**RE: ADDENDUM #10 TO THE COMSTOCK MINING INC., CARSON RIVER MERCURY SUPERFUND SITE SAMPLING AND ANALYSIS PLAN**

On behalf of Comstock Mining Inc. (Comstock), McGinley and Associates (MGA) is providing this Addendum #10 for the Process Area as shown on the attached Figures 1-3. These Figures address the 40 acres south and the 40 acres east of the existing Process Area.

ISSUED FOR: -	
DRAWING NO. <b>Figure 1</b>	REVISION NO. <b>A</b>
SRK JOB NO. <b>COM000.A008</b>

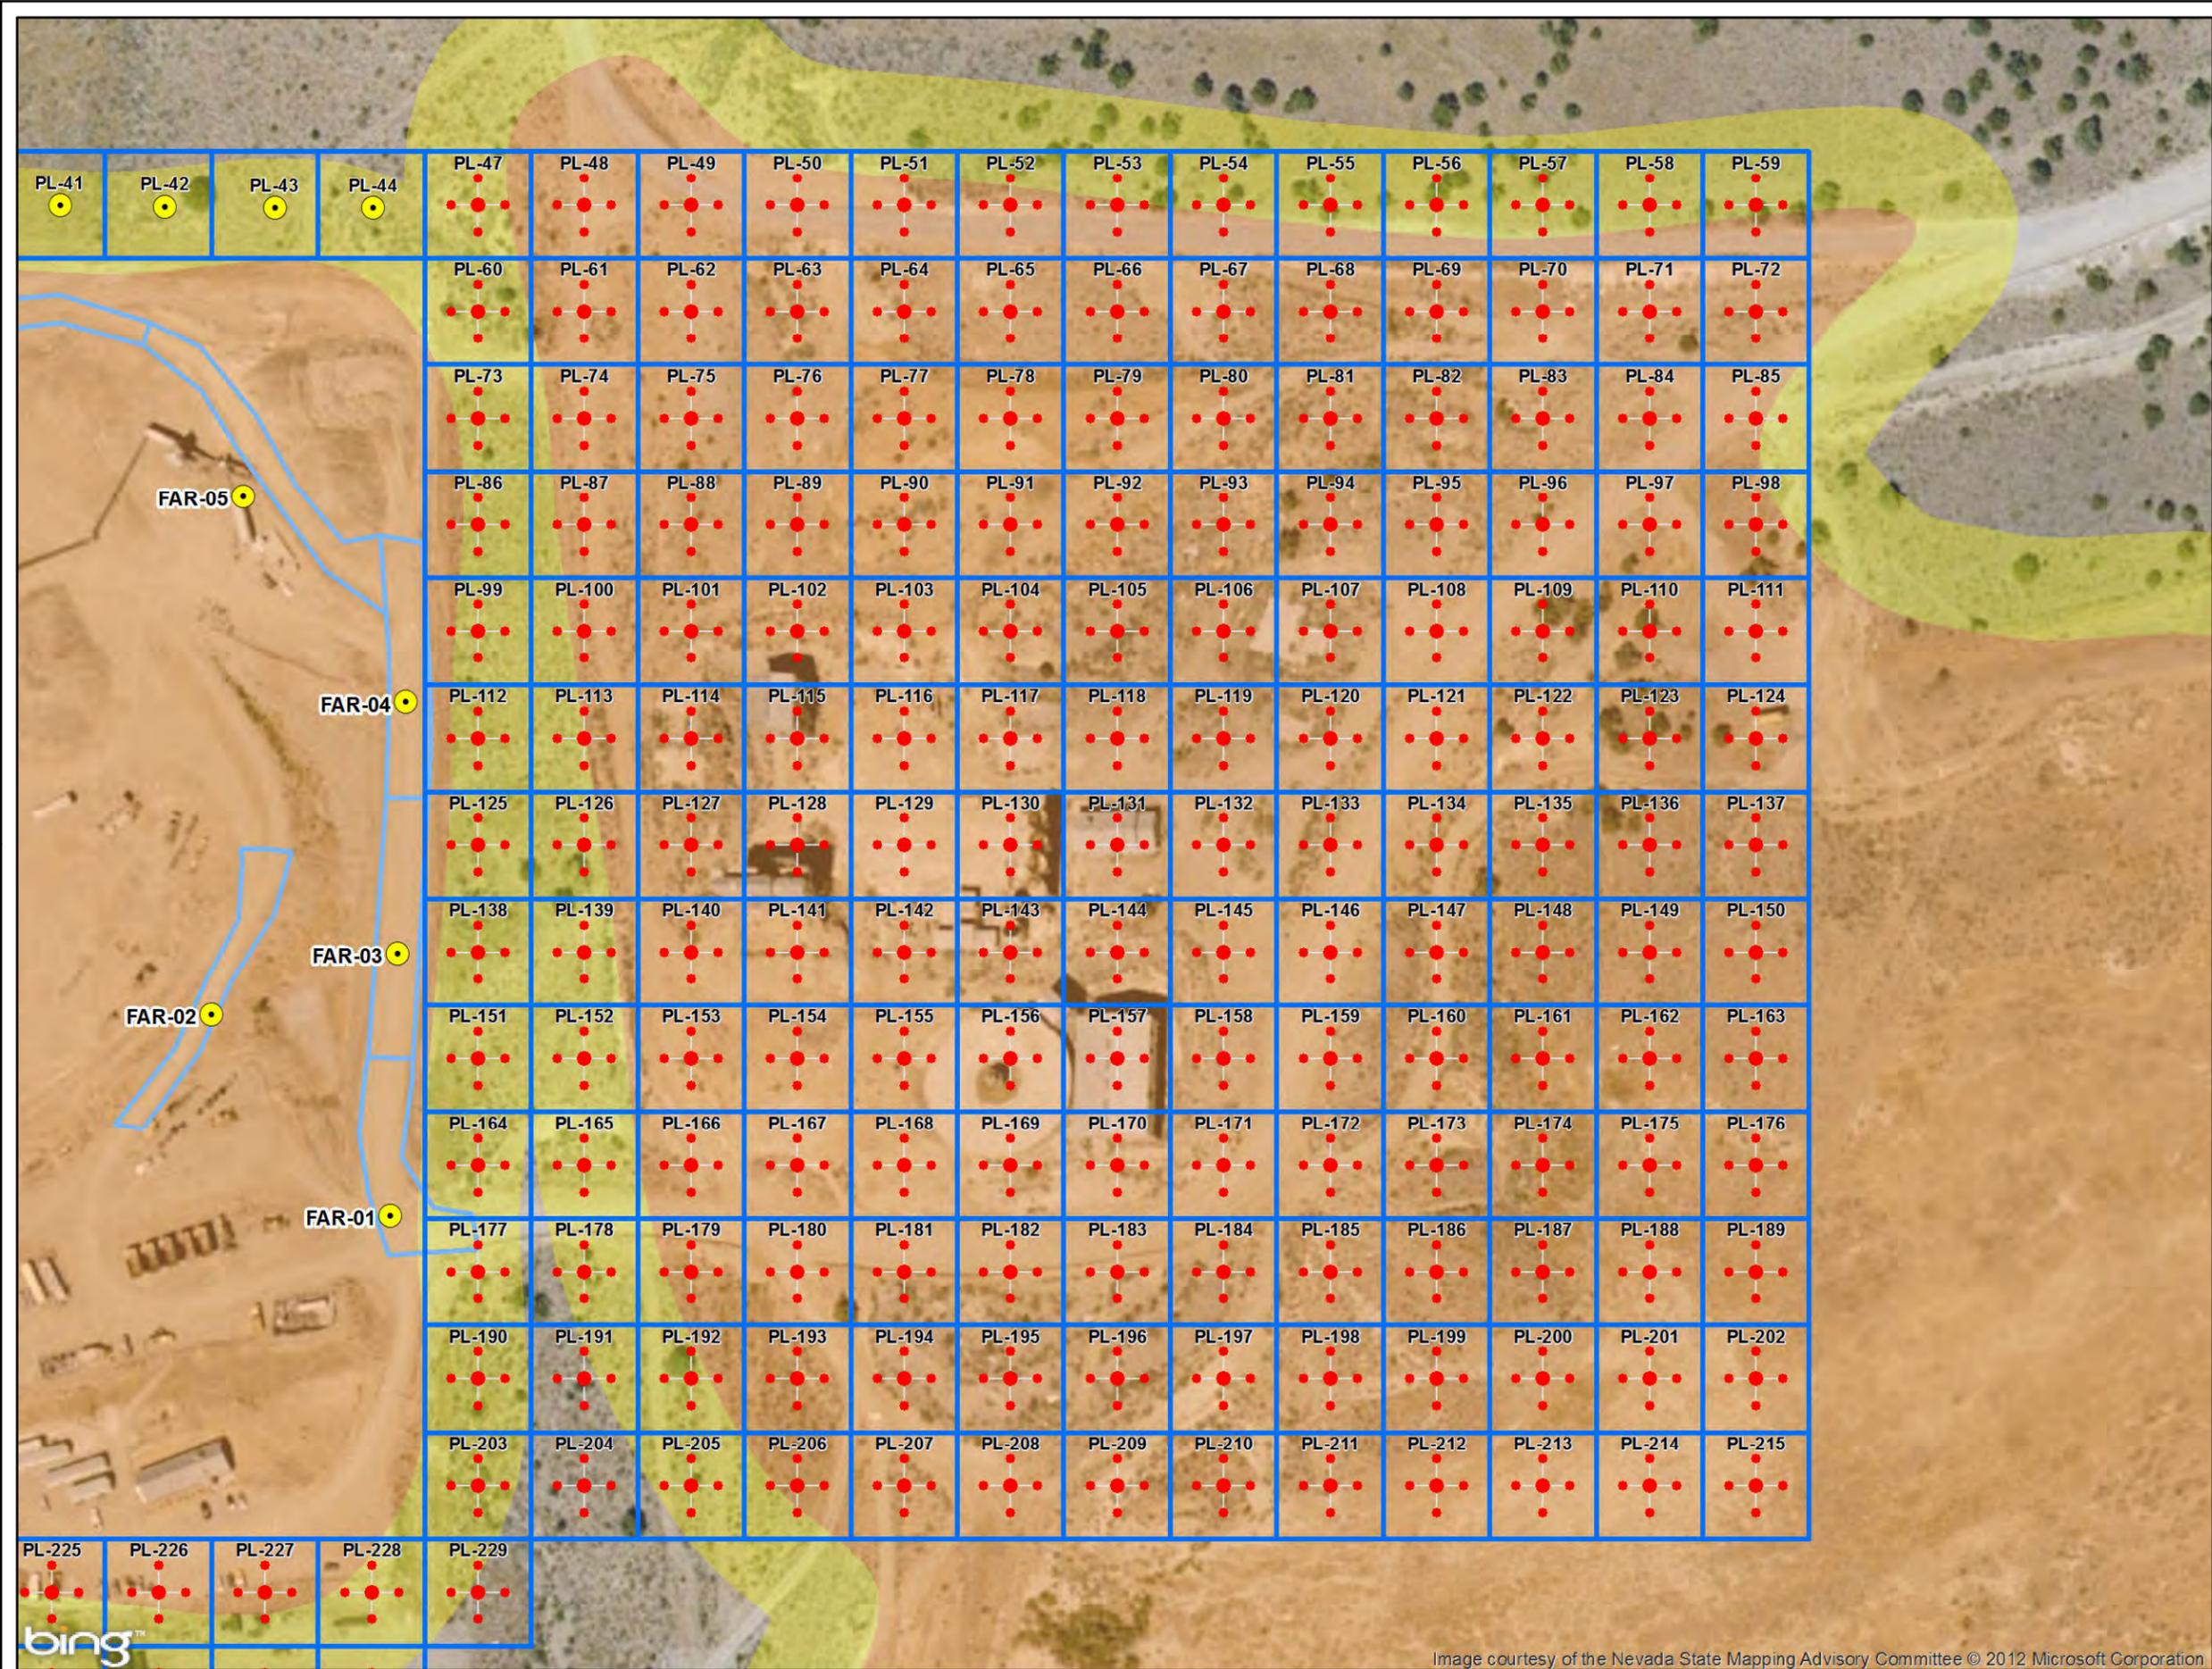
Comstock proposes to install 1,192 5-point composite samples at 298 locations as shown on the attached Figures 1-3. This includes 298 ¼ acre quadrants. These samples will be installed from 0-2' below ground surface (bgs) with samples taken at 0-6", 6-12", 12-18" and 18-24" bgs consistent with previous sampling efforts.
